# NMA - PL6

## Flitcroft House

## 1.1 Introduction to Revisions

In accordance with the approved scheme (2022/3335/P), granted on 11.10.2023, DMBA, in collaboration with E&A Property Investment Company Ltd., is seeking approval for a series of minor amendments to the development.

## 2.1 Fire Engineer Comments to Consented Roof Terrace Plan

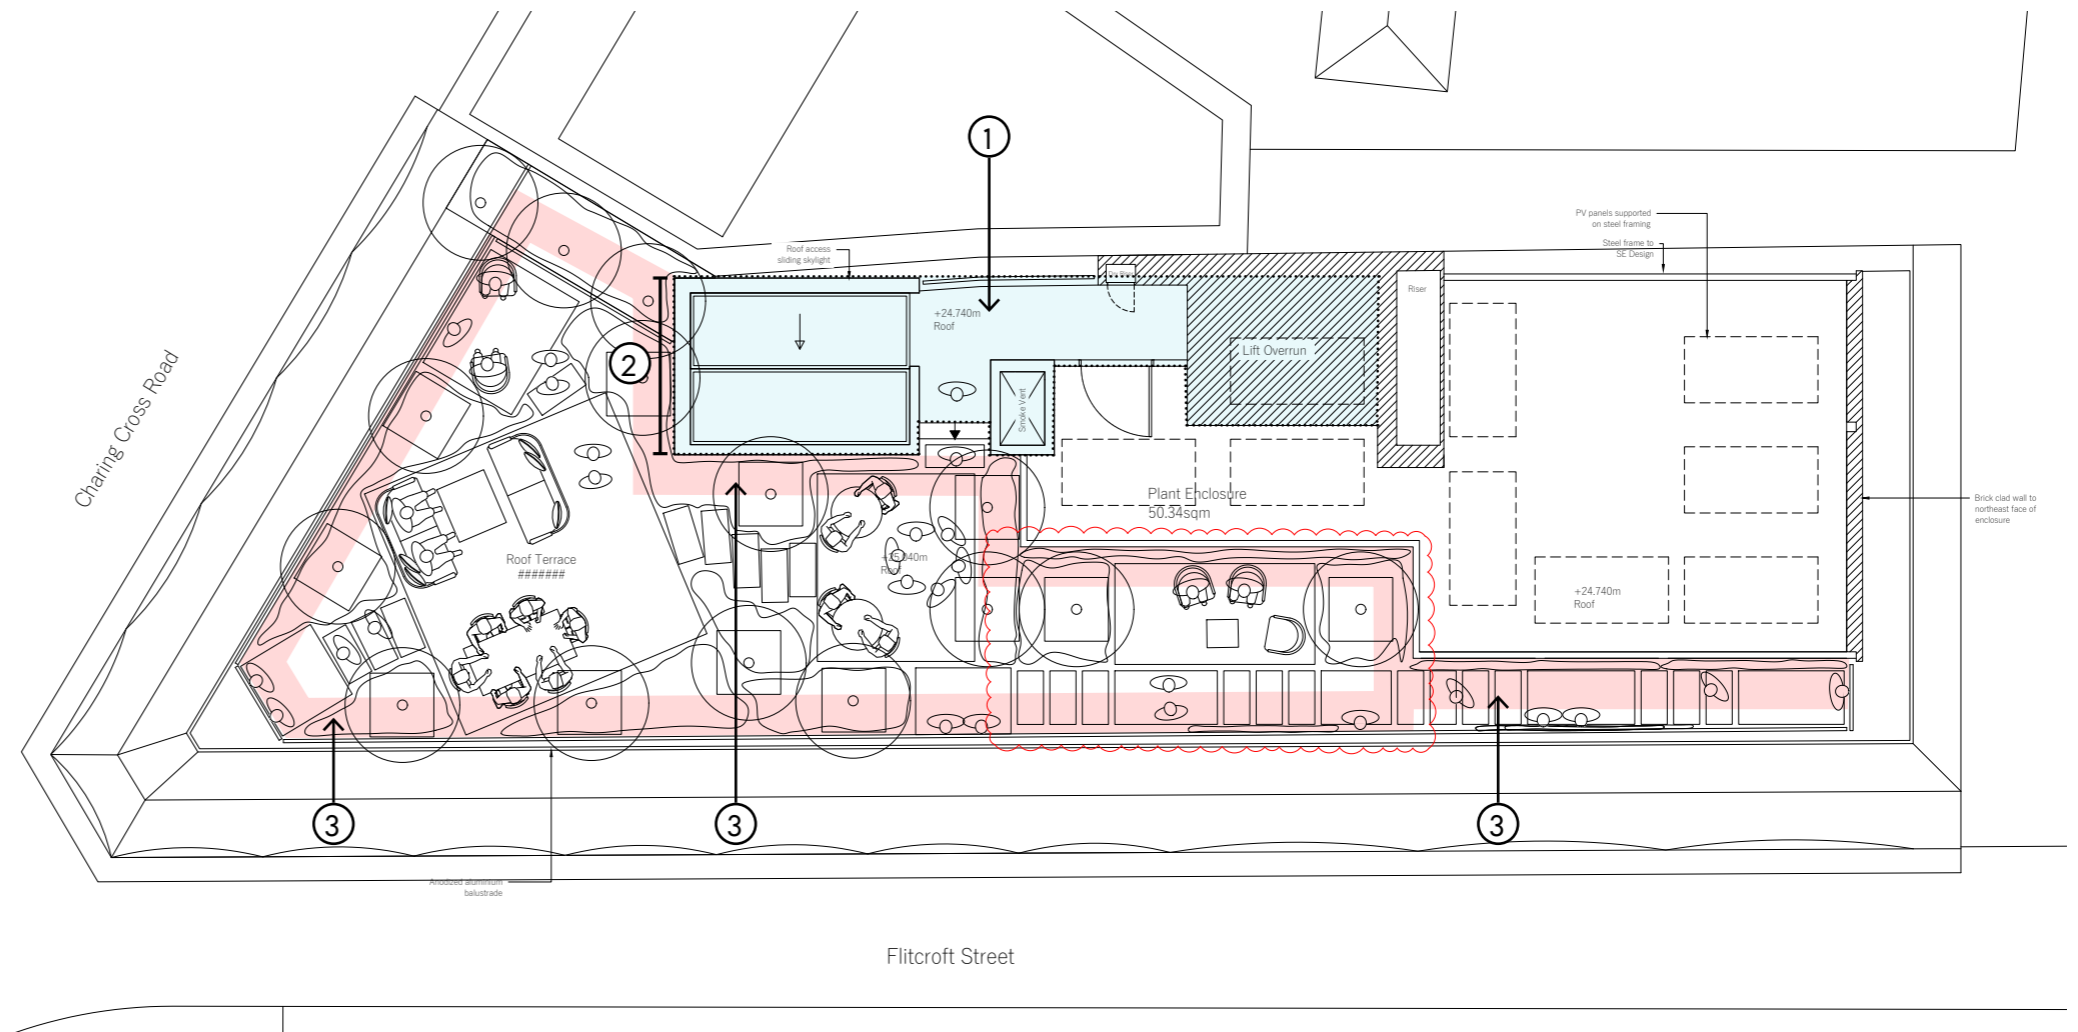
**1.** The fire fighting core and lift shaft to be extended to roof terrace level, as this is an occupied floor.

- Evacuation lift to be extended to roof terrace level.
- Stair core to be extended to roof terrace level.
- Mechanically ventilated lobby to be provided between stair core and fire fighting lift.

**2.** The stair width to be increased to a minimum of 1200mm each direction, to accommodate upward and downward travel.

**3.** A fire break is required between the plant screen, the party wall, and the proposed roof terrace landscaping.

## 3.3 Revising the Landscape & Roof Terrace FFL

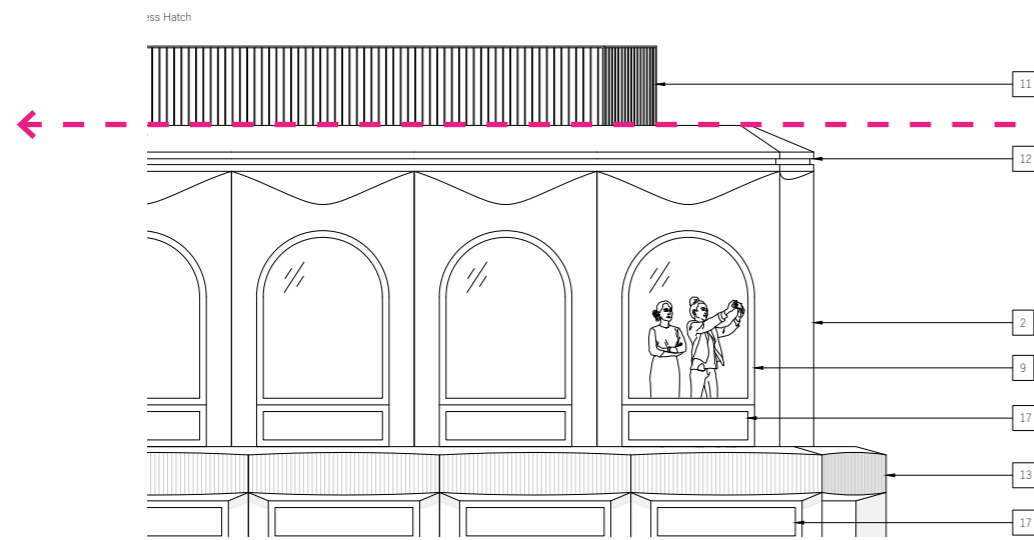
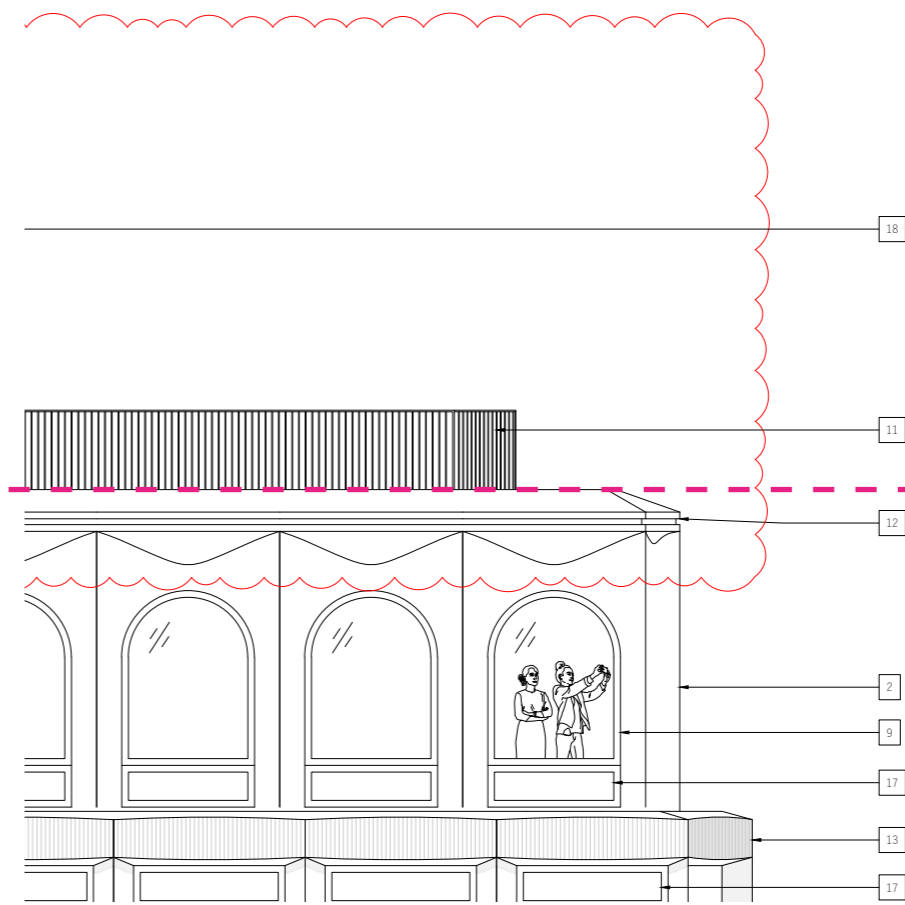
To minimize the impact of the increased 150mm parapet up-stand required at roof terrace level, the overall buildup of the proposed roof terrace has been reduced. The impacts of this are:

- Tree planting strategy has been revised from threshold planting to raised above the FFL
- Reduction in overall FFL at roof terrace allows for the stairs to maintain a regular riser pattern, that continues from the lower floors.
- The reduction allows for the stair core footprint to remain as per the lower levels at roof terrace level, removing the need to extend the stair core and overrun towards Charing Cross Rd which would have reduced the landscaped area.
- Parapet height consistent with previously consented proposal.
